The City of Spartanburg Design Review Board

AGENDA

September 2, 2025, at 5:30 P.M.

Meeting Minutes of the Design Review Board (DRB)
Tuesday, August 5, 2025, at 5:30 PM
Dr. TK Gregg Recreation Center

Ballroom Floor Plan – Previously Approved

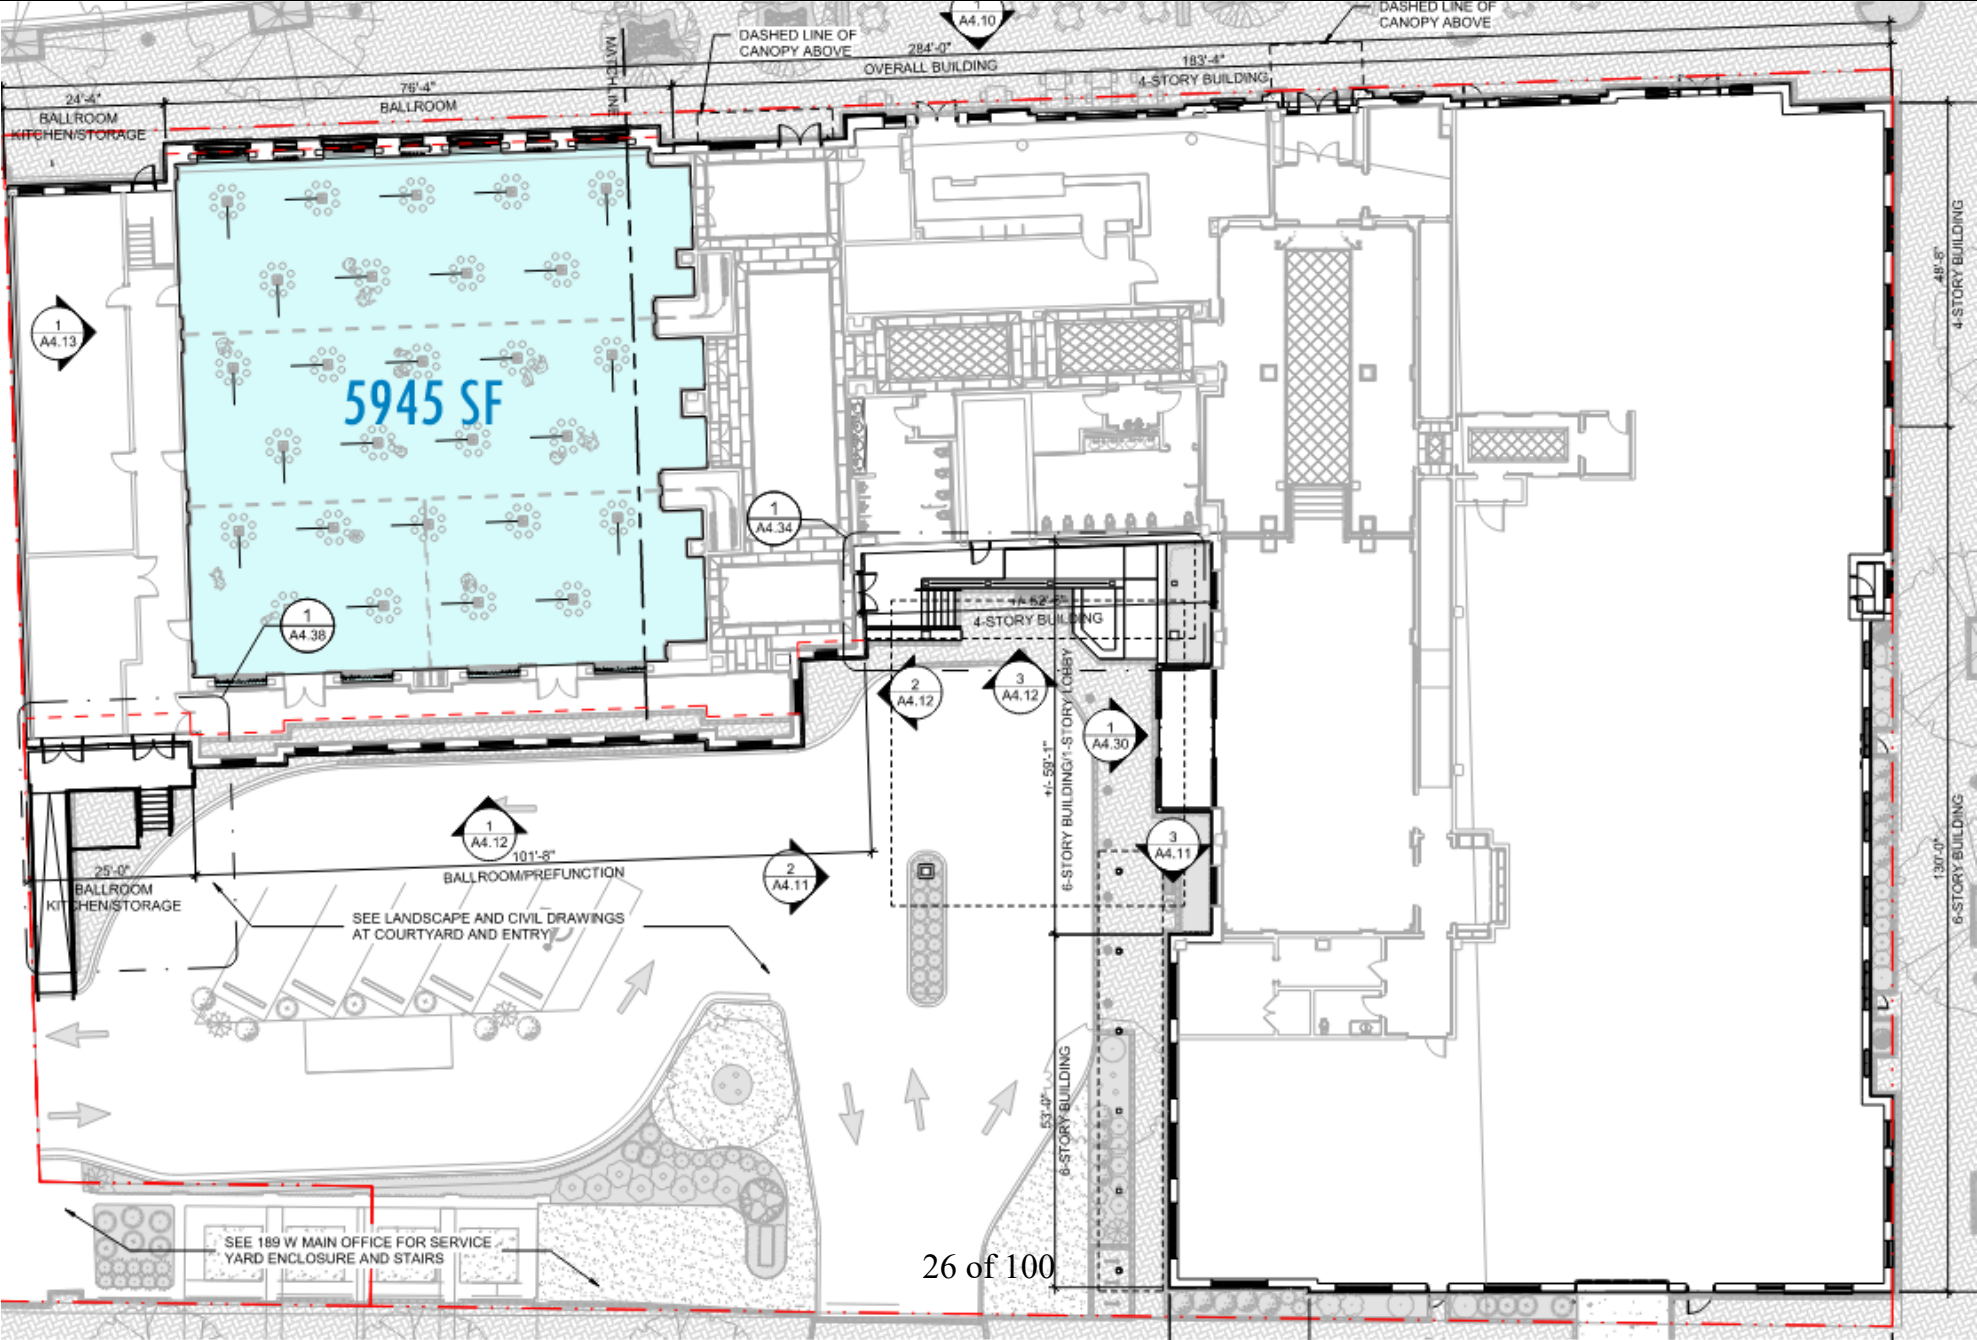
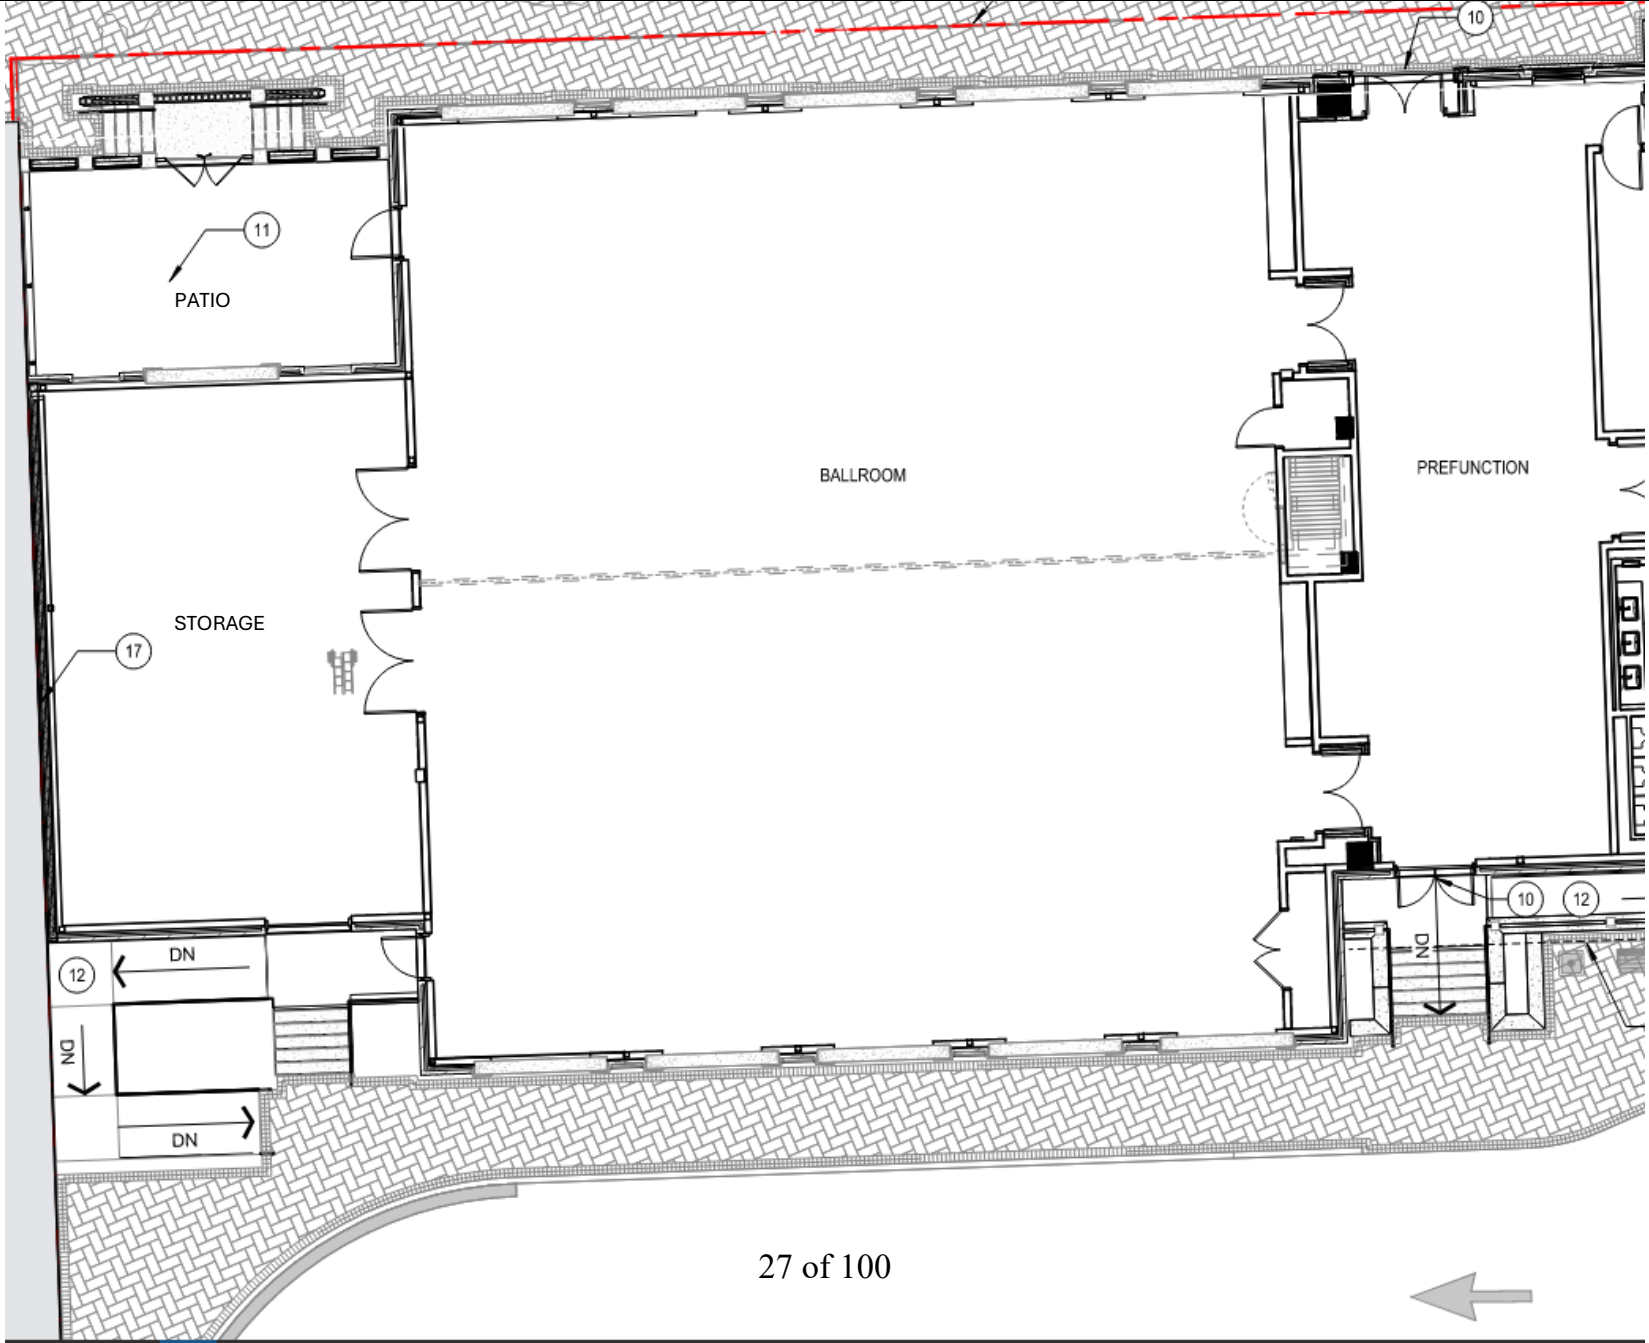
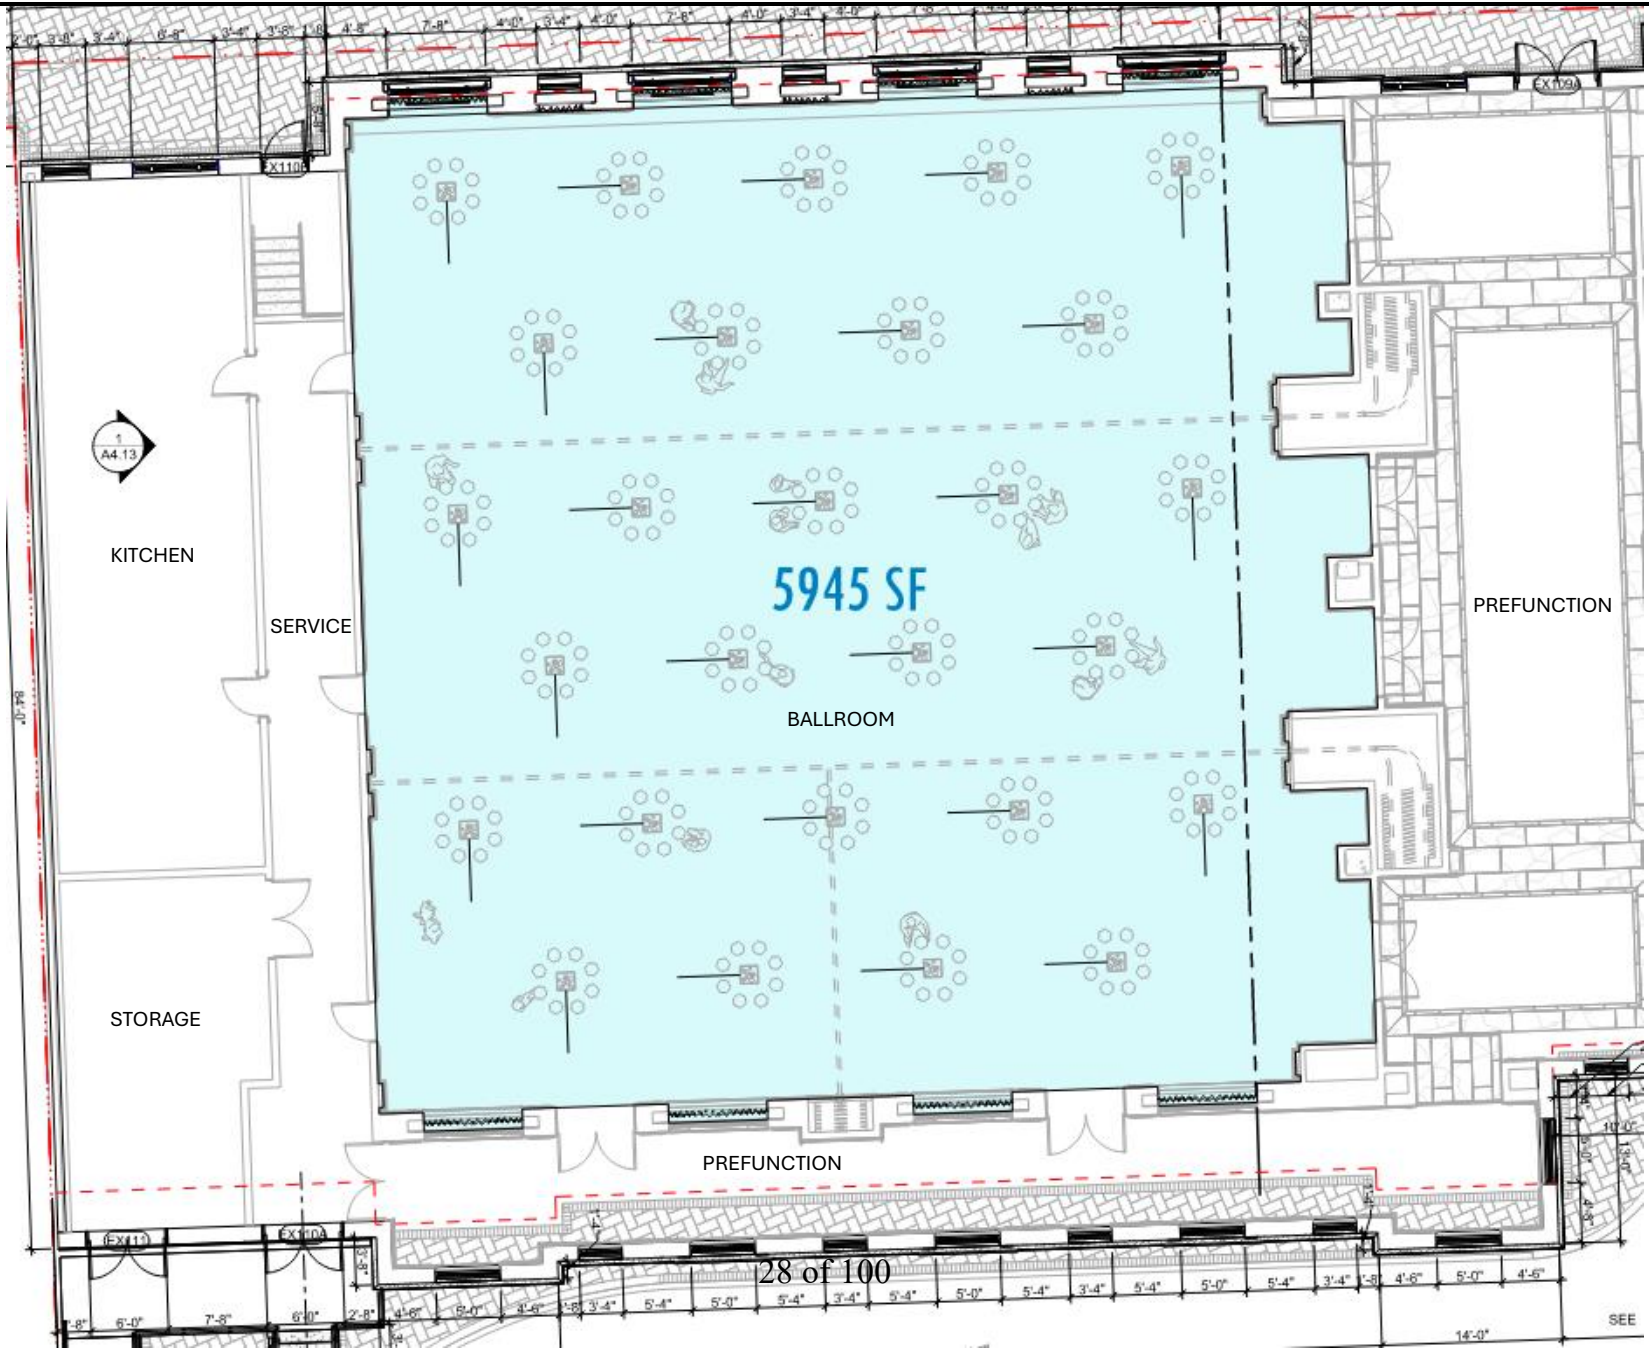
- OTO Development is planning to expand the ballroom to account for operational concerns such as accommodating a catering kitchen, storage, and service corridor. This results in growing the ballroom West and South. The exterior alterations to the design include removal of exterior patio and revised façade to the one-story ballroom fronting Main Street.
- In January 2025, OTO presented the ballroom associated with the hotel as a single story and was approved by Spartanburg's Design Review Board. OTO Development is requesting an amendment to the previously approved variance to 3.3.4a, building height in DT-6.

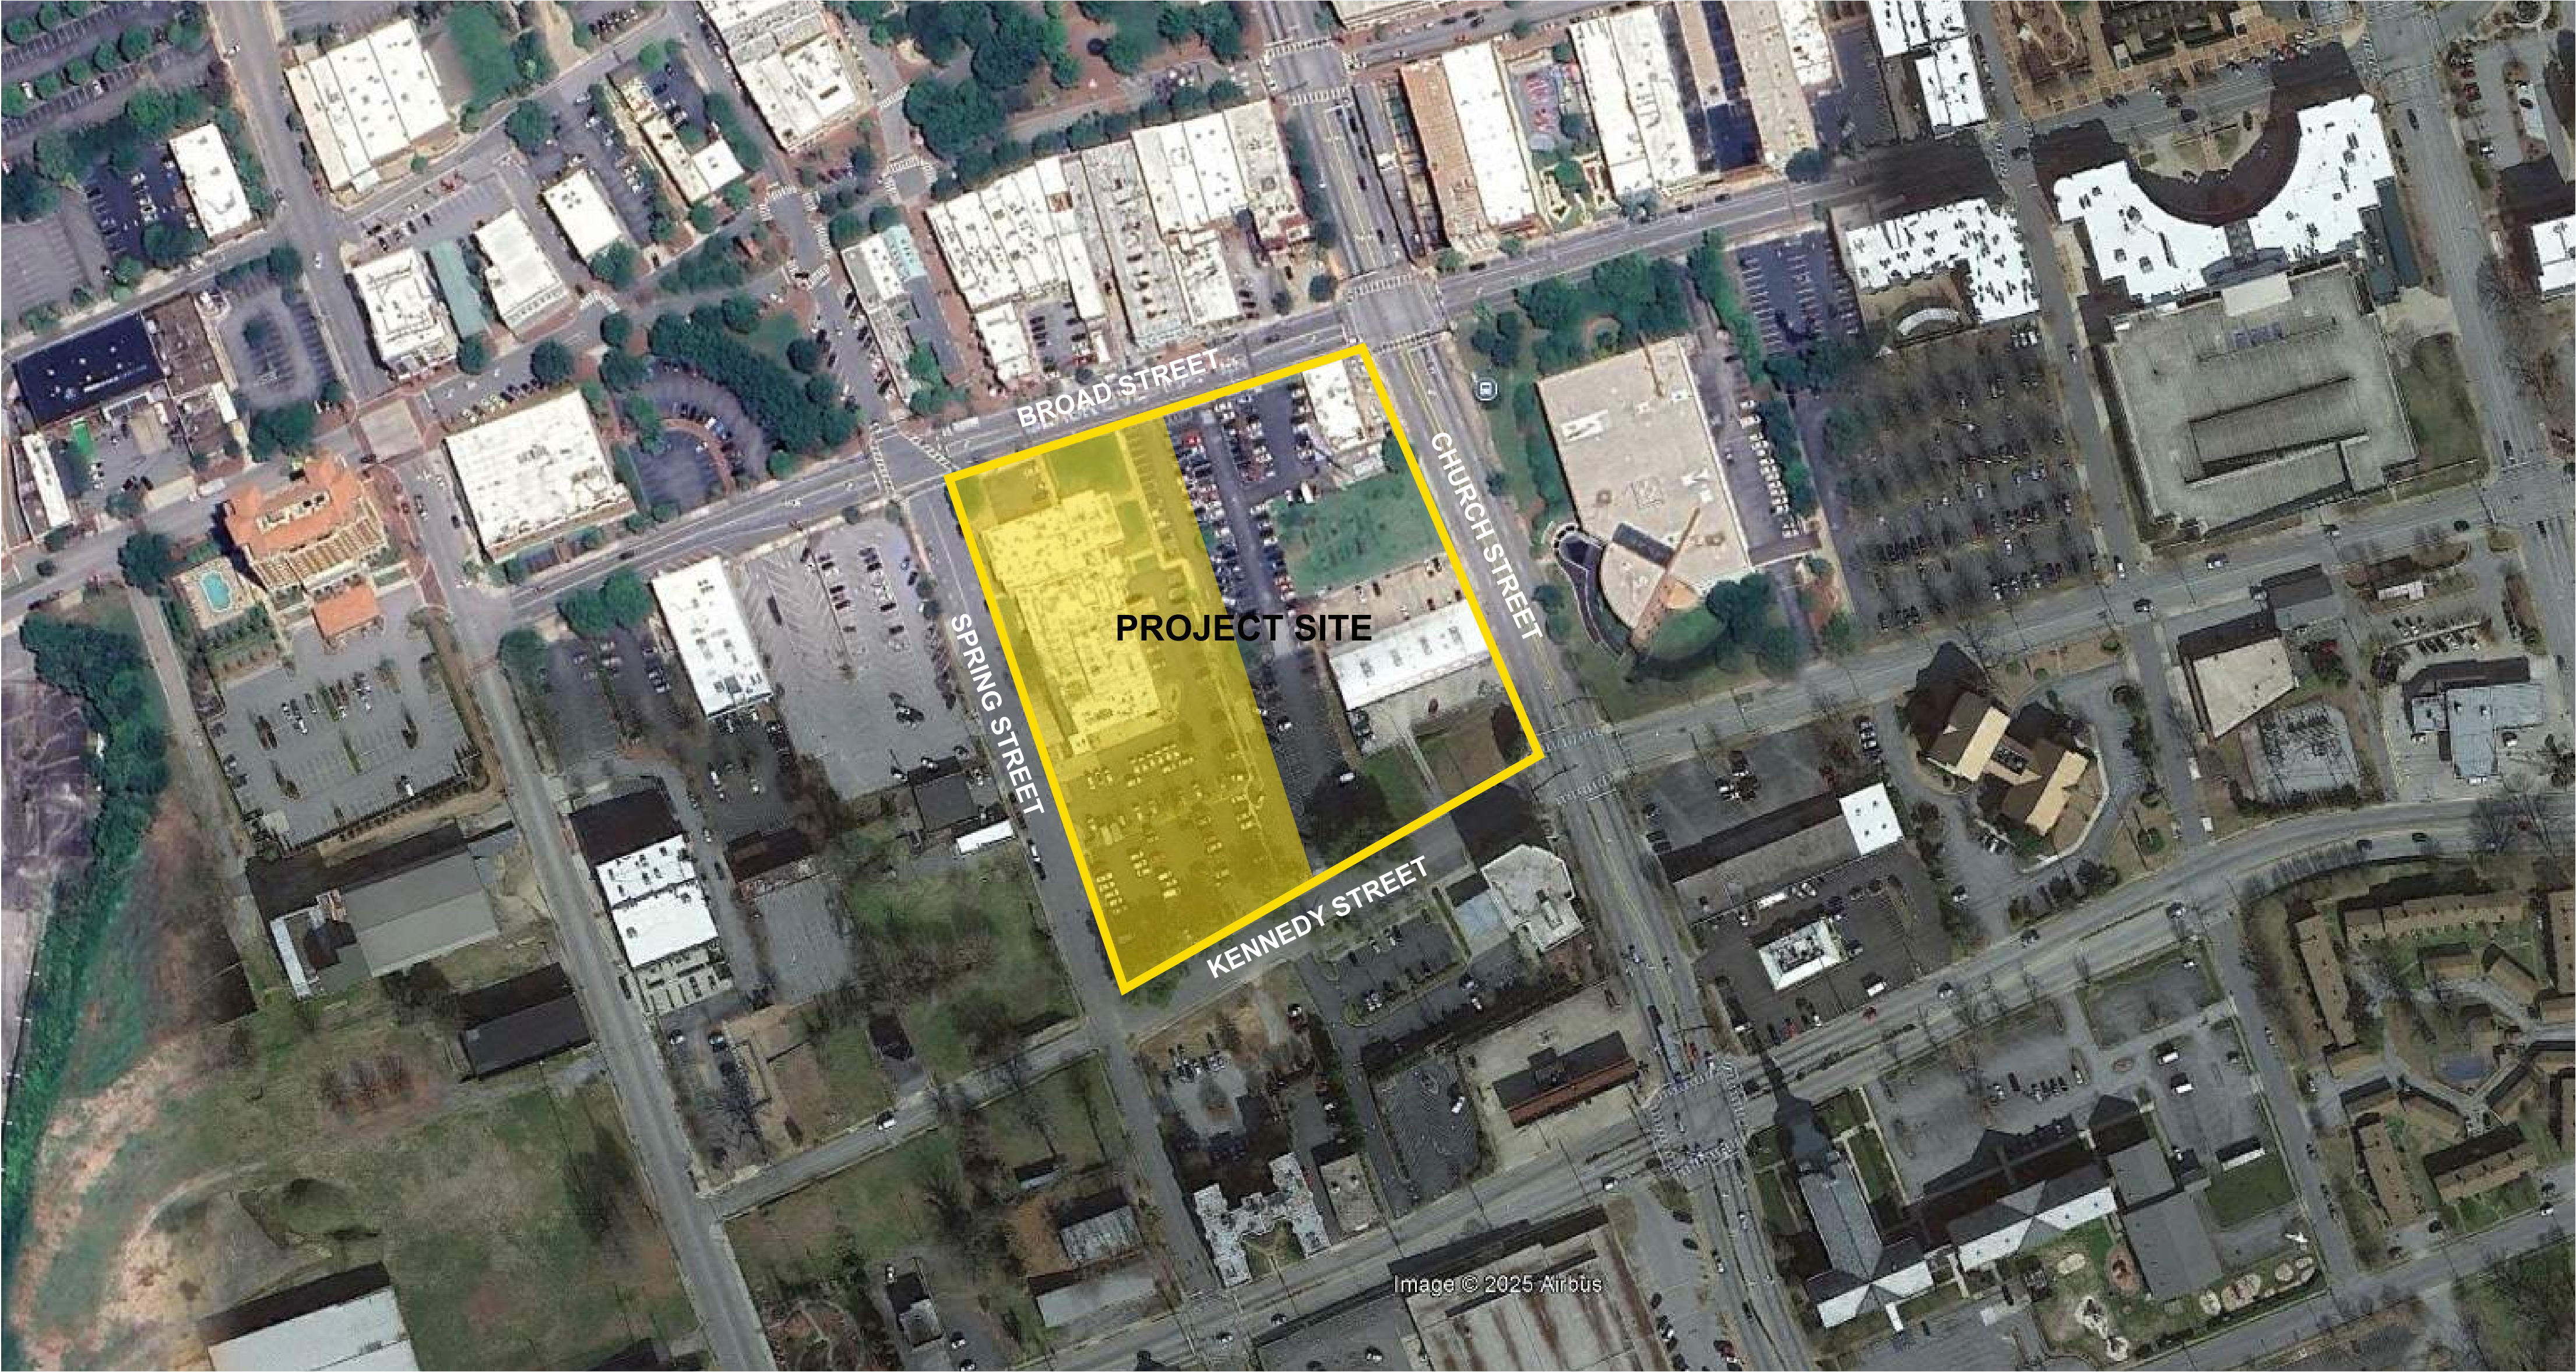
Requested Variance: Permit a vehicular entrance width of 63 feet at the Kennedy St. entrance to the structure.

Preliminary Review Planning Staff Comments: explore the option of reducing lane widths to evaluate potential impacts on the deck's functionality, as well as the integration of pedestrian safety crossing measures.

Explanation: We have adjusted the lane and curb layout at the Kennedy St entrance per recommendations from the DRB and planning staff. We have added a 4" high concrete curb at the mid span of the driveway to serve as a pedestrian refuge while crossing at the parking deck entrance. This island will also slow down traffic and prevent vehicles from making wide turns into and out of the deck. We have also reconfigured the two exit lanes so that right-most exit lane can only turn right and the leftmost exit lane can only turn left. Additionally, we have reduced the width of each lane which reduces the total width of the parking deck opening from 68' to 63' (measured parallel to Kennedy St.).
